June 12, 2009

Subject: UniStar Nuclear Energy, NRC Docket No. 52-016
Response to Request for Additional Information for the
Calvert Cliffs Nuclear Power Plant, Unit 3,
RAI No. 109, Seismic Classification

**Response to NRC Request for Additional Information
RAI No. 109, Questions 03.02.01-1, 03.02.01-2 and 03.02.01-4, Seismic Classification
Calvert Cliffs Nuclear Power Plant, Unit 3**

Figure 9.5-2—(CCNPP Unit 3 Fire Water Distribution System - Cooling Tower Loop)

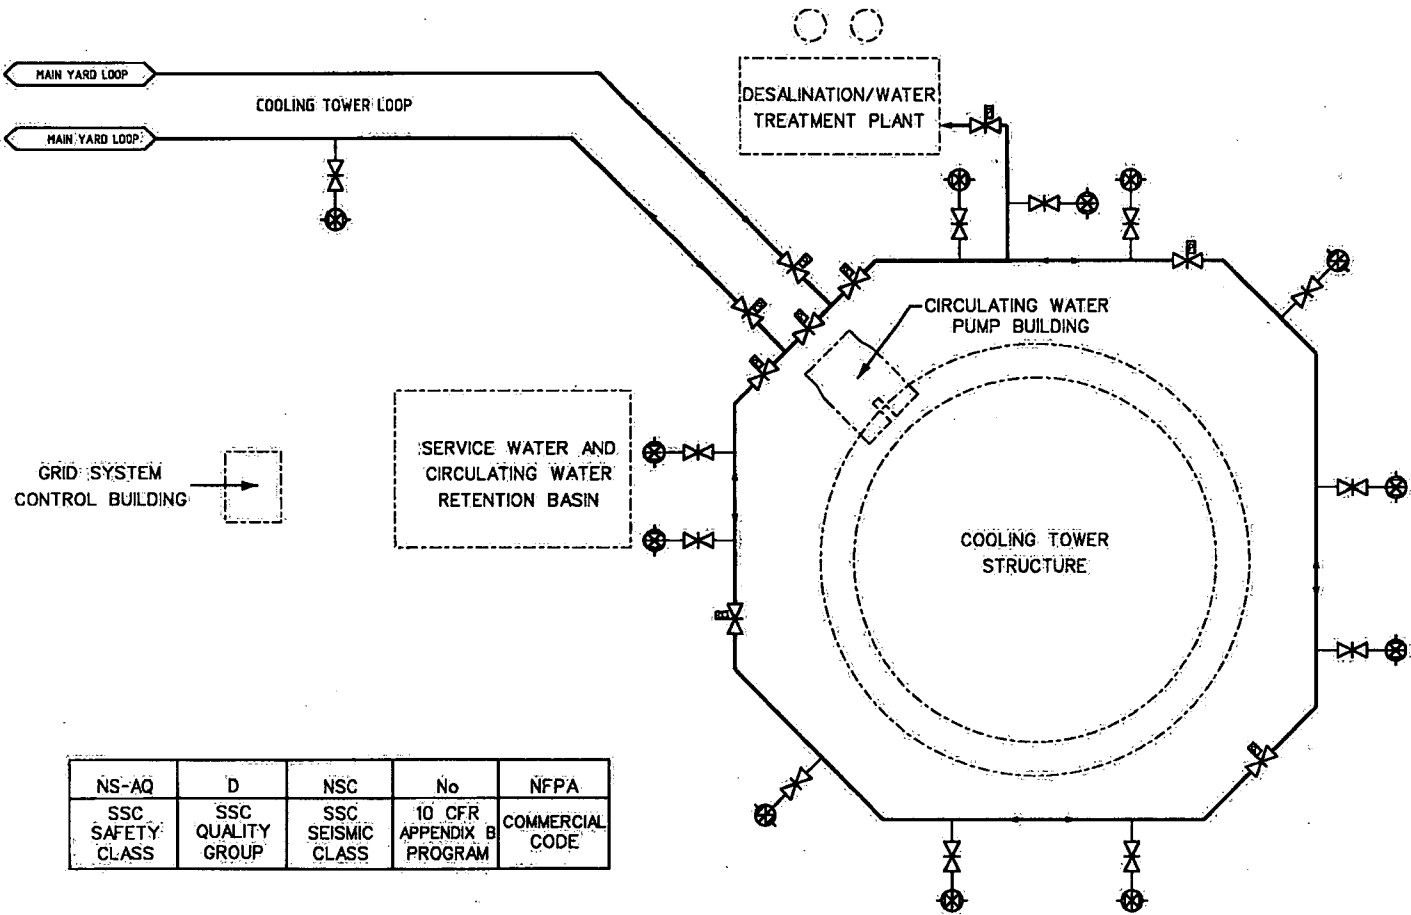
Site-specific SSCs for the fire water supply system and the fire suppression system were added to CCNPP Unit 3 FSAR Table 3.2-1. However, the site-specific piping and instrumentation diagrams (P&IDs) for the fire protection system cannot be located in the CCNPP Unit 3 FSAR. Provide the simplified fire protection system P&IDs in the FSAR showing the site-specific SSCs including seismic category.

Simplified fire protection system P&IDs (FSAR Figures 9.5-2 and 9.5-3) showing the site-specific SSCs, were previously provided in response to RAI No. 75 Question 09.05.01-4².

FSAR Figures 9.5-2 and 9.5-3 will be revised to identify the SSC Seismic Category, consistent with FSAR Table 3.2-1. In addition, FSAR Table 3.2-1 and COLA Part 10 ITAAC Tables 2.4-26 and 2.4-27 will be revised for clarity and consistency.

FSAR Figure 9.5-2 and Figure 9.5-3 will be revised as follows in a future COLA revision:
